## **Appendix**

Subject: Peer Review– Symmes Redevelopment Plan Traffic Impact Study and Mitigation Plan

Subject: Status Report - Arlington, MA – Symmes Update Peer Review and  
Arlington TAC Technical Assistance

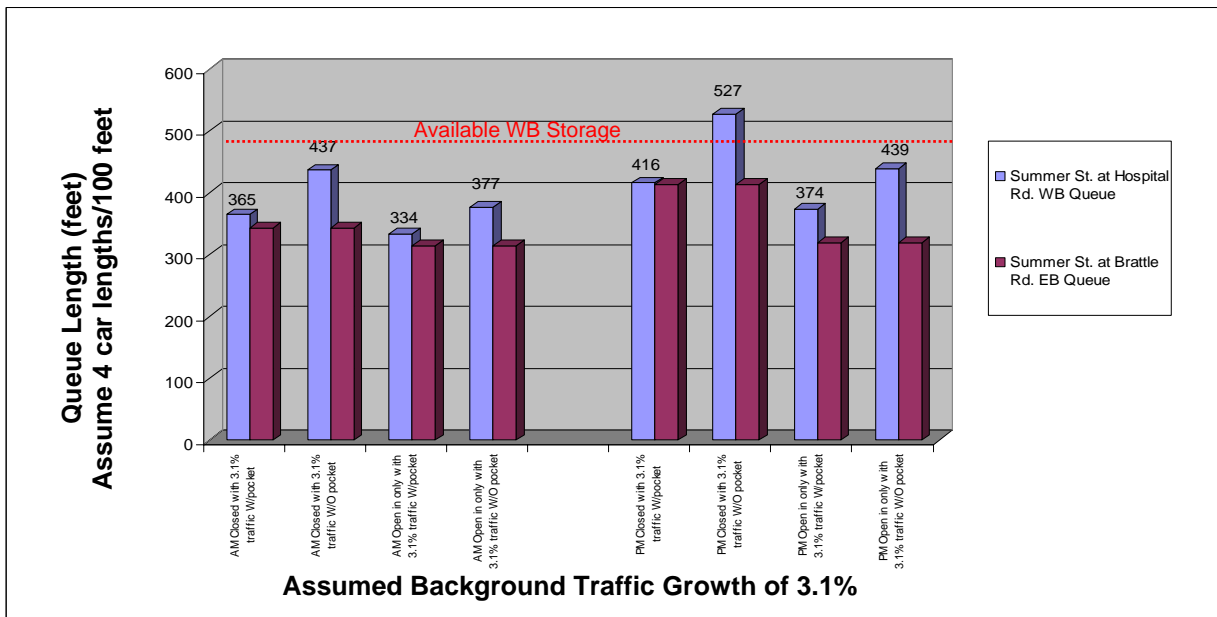
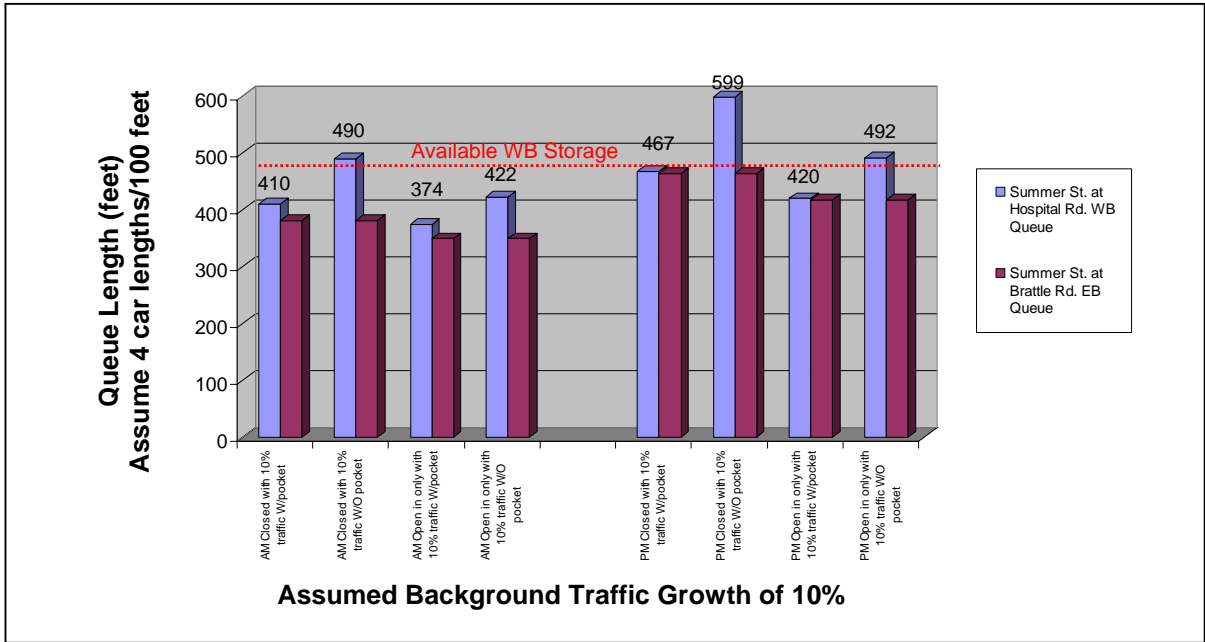
*Issue 1 - The proposed 200-foot long right turn pocket on the north side of Summer Street approaching Hospital Road:*

- The proposed turn pocket has environmental issues (removal of a couple of trees and green space) that may offset its traffic benefits.
- With the assumed Summer Street background growth totaling 3.1% to the design year, it is concluded that the addition of the right turn pocket lane typically reduces the AM and PM peak hour queues on Summer Street by approximately 2-4 car lengths depending on whether Woodside Lane is open or closed.
- With an assumed Summer Street background growth totaling 10% to the design year (also refer to the chart on the next page, it is concluded that the addition of the right turn pocket lane typically reduces the AM and PM peak hour traffic queues on Summer Street by approximately 3-5 car lengths. (refer to charts on the page that follows).

Based on the historical Summer Street traffic volumes, it is not unreasonable to assume that Summer Street may at some point carry traffic volumes similar to those it carried several years ago. Even with a 10% assumed growth in traffic on Summer Street, its traffic can grow approximately another 15-20% during peak hours in the peak flow direction before the corridor becomes saturated.

**Conclusion:** The right turn pocket is beneficial from a traffic perspective, as it reduces queues toward Grove Street. The question is the trade-off between the green space lost vs. the reduced traffic queues. This is a community value issue. Similarly, with Woodside Lane open one-way to Symmes inbound traffic, the difference in queuing with the right turn pocket is approximately 1-2 car lengths. With Woodside Lane closed to all Symmes traffic, the difference in queuing is 2-3 car lengths without the turn pocket.

*Woodside Lane looking east at Hospital Road*

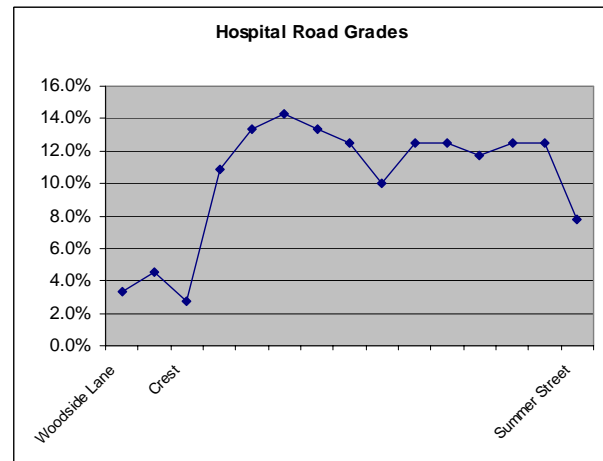
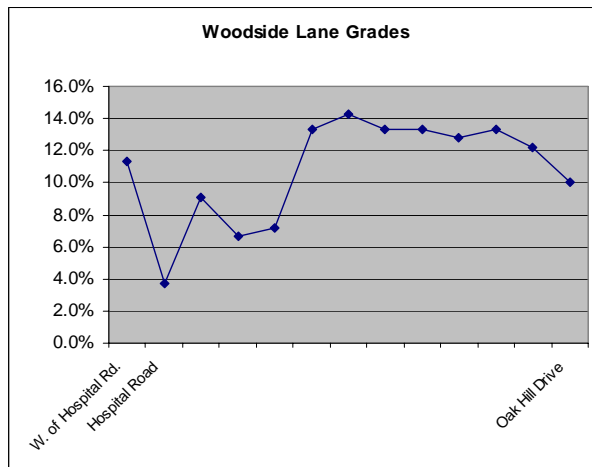
From the photos below, it is evident that winter/summer conditions along Woodside Lane differ significantly. On one hand Woodside Lane vegetation sight distance deficiencies (see

left) are reduced during the winter months. However, sight lines at driveways diminish during heavy snow conditions such as those encountered recently.

**Conclusion:** During our initial review, FST recommended that Woodside Lane provide emergency, pedestrian, and bicycle access. We see no reason to change this recommendation in light of its constricted geometric and sight line conditions and its functional capacity. We note that emergency access means that there must not be a locked gate, according to recent Arlington Deputy Fire Chief discussions with the TAC.

Potentially, *restricting inbound access to less than 40 vehicles per hour during peak hours* from Woodside Lane is a reasonable option that can be considered for testing if monitoring equipment is installed at the Woodside Lane entrance and the findings are regularly made available to Woodside Lane neighbors.
